**ADDENDUM REPORT**

**ENVIRONMENT & SOCIAL IMPACT ASSESSMENT (ESHIA) OF THE PROPOSED  
SIRAJGANJ 225MW COMBINED CYCLE POWER PLANT PROJECT (DUAL FUEL-3<sup>RD</sup>  
UNIT), SAYDABAD, SIRAJGANJ**

Figure 1: Revised Water Diagram of NWPGL Unit 3

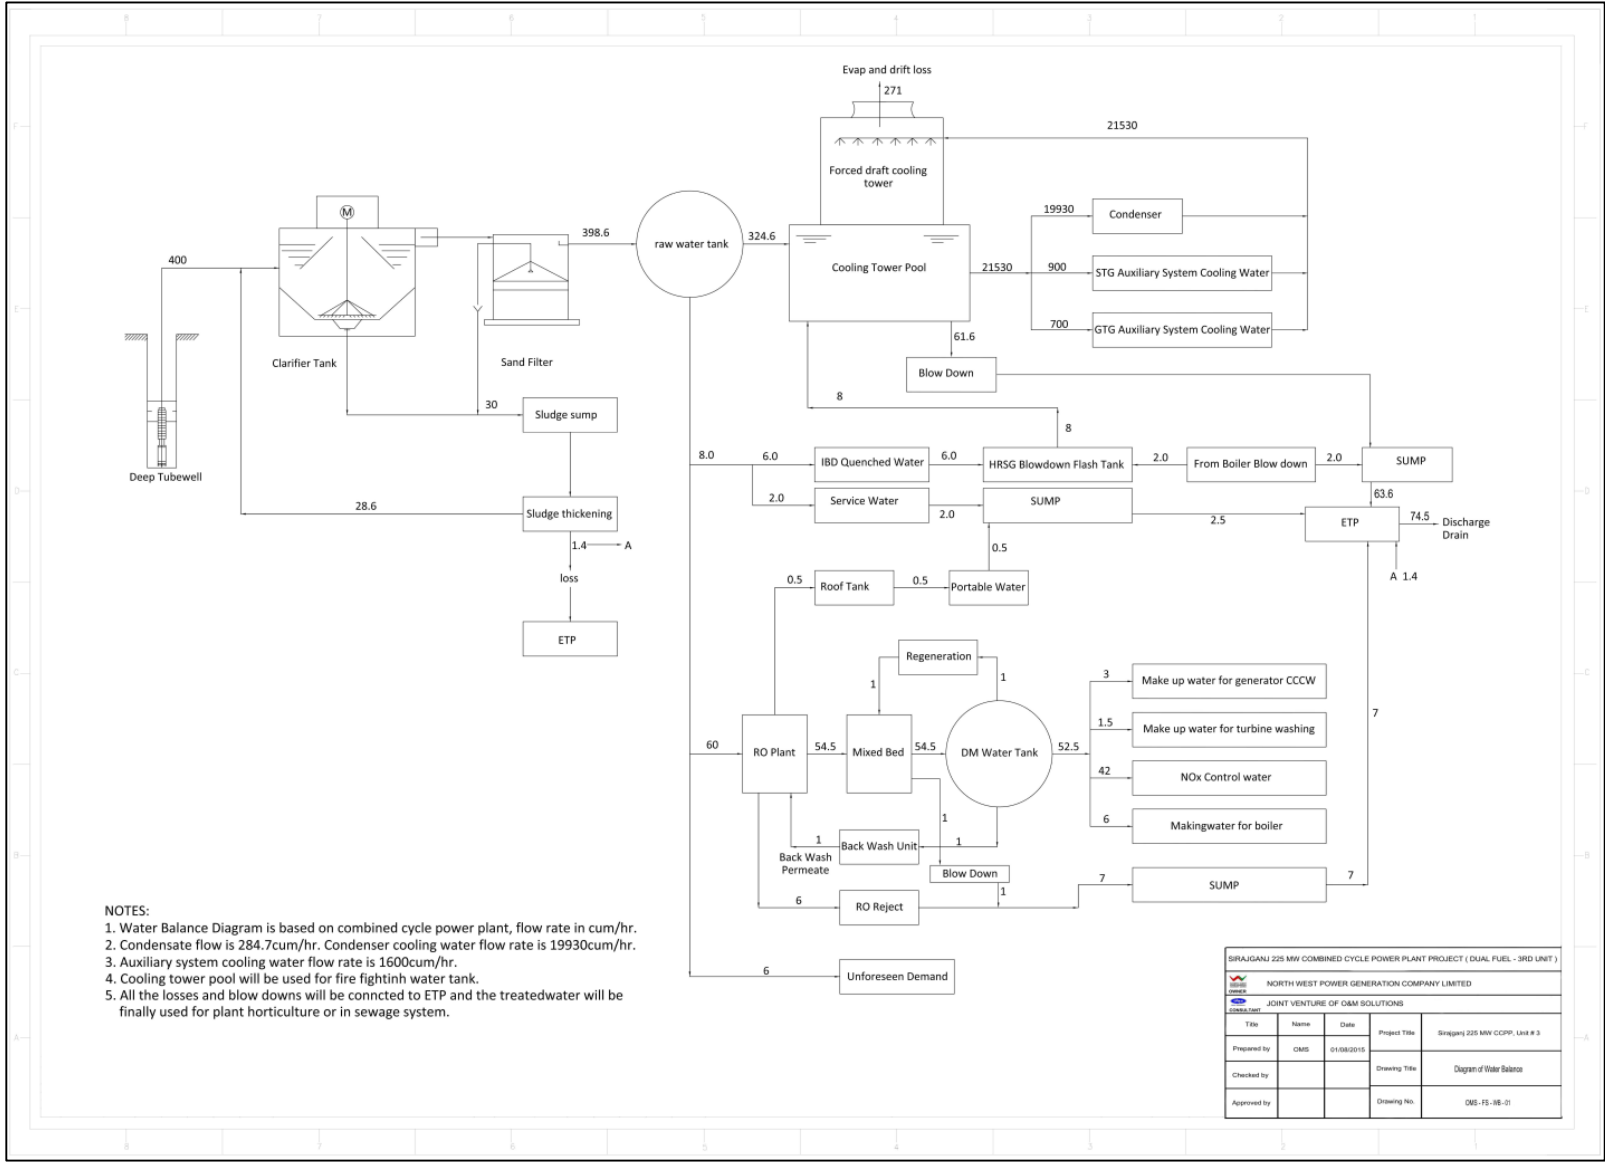
The Demineralized Water treatment plant as shown in figure 4-2 of ESHIA report has been replaced with provision of Reverse Osmosis (RO) Plant. The revised water diagram has been presented below.

One block water requirement will be 50 cubic meter per hours. This will meet by RO plant consists of two trains, each of 50% capacity for the demand of one block. During natural gas firing one stream meets the requirement, whenever liquid fuel firing happens both blocks will be operating to meet the additional De NO<sub>x</sub> water injection requirement. During cleaning of the membranes, only one train shall be in operation (it will be planned only when plant is operating on gas fuel). Any shortfalls in water shall be taken from the permeate storage tank.
